Thor Motor Coach Recall Repair Instructions

Recall #	24V-666 2024-520		
Description/Title:	2024 Transit LP Heatshield		
Affected Product Line(s):	Certain MY 2024 Palladium & Talavera motorhomes		
Service Campaign # :	RC000314		
Repair Code:	Inspect with Repair: TMCRC80501V	Document Date:	MM/DD/YYYY
Time Allowed:	Inspect with Repair: 1.0	Document Revision:	A

It has been discovered that on Certain MY 2024 Palladium and Talavera Motorhomes, the LP tank heat shield is the incorrect size.

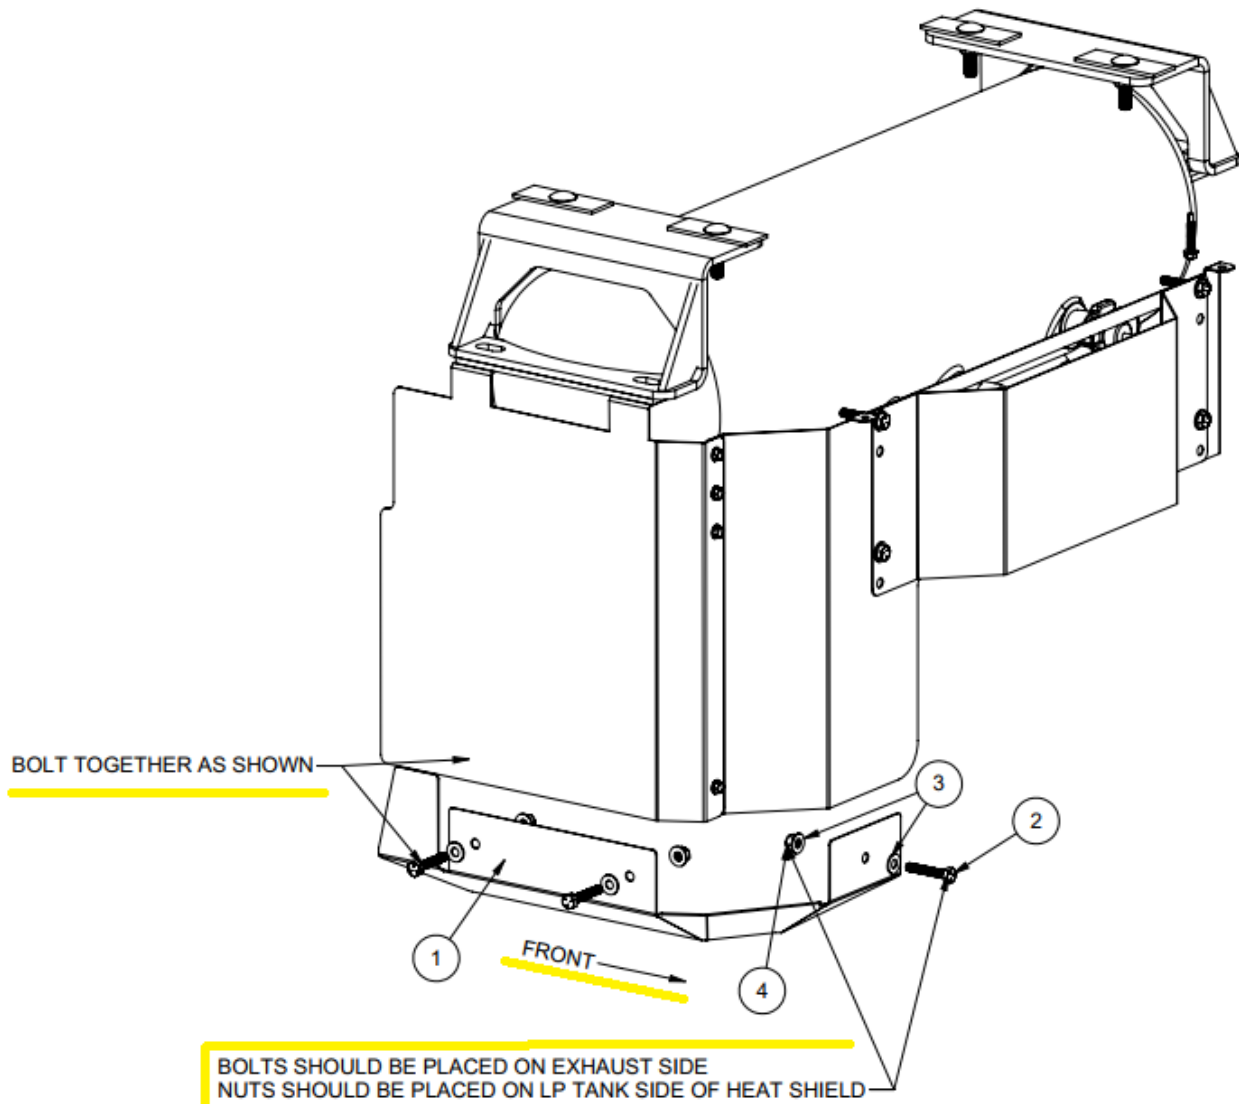
1. Align heatshields together and predrill holes in existing heatshield

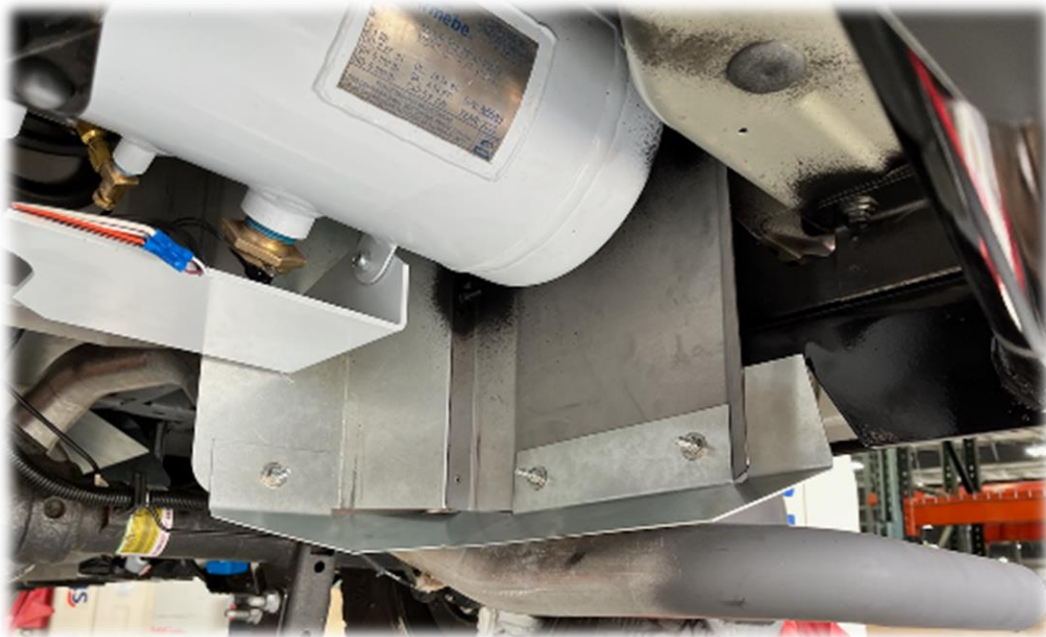
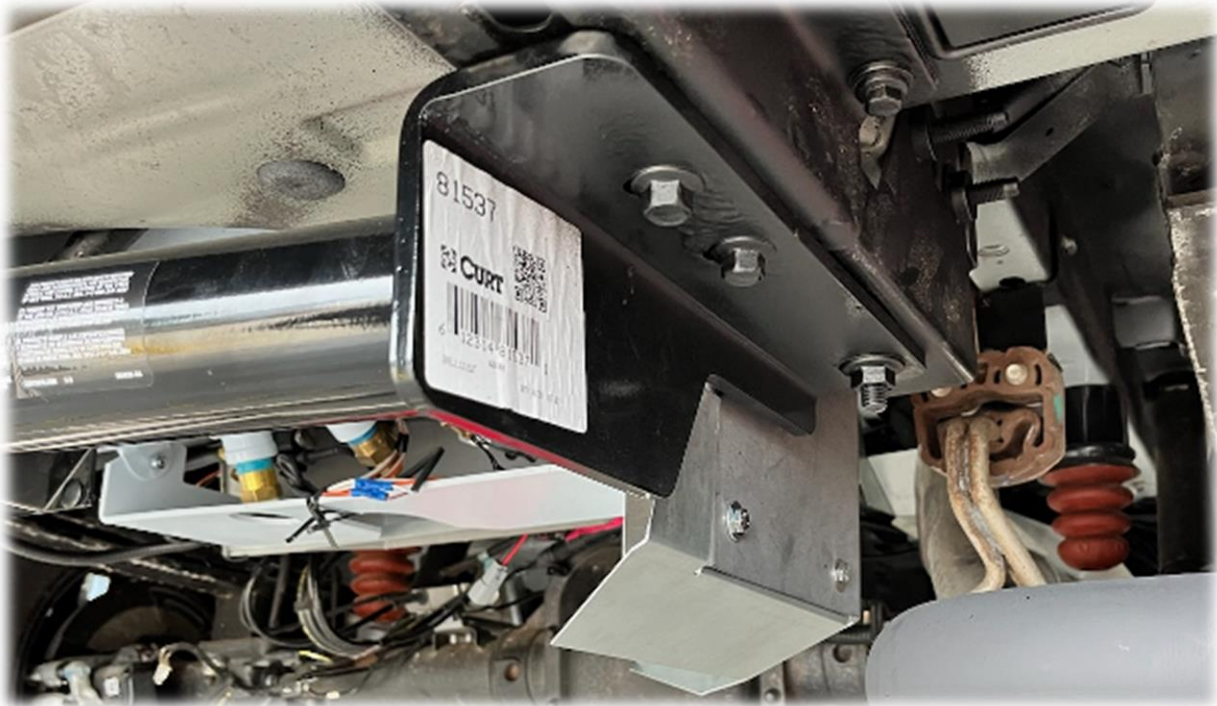
2. Bolt (#2) together on exhaust side, nuts (#4) to be placed on LP tank side of heat shield (#1).
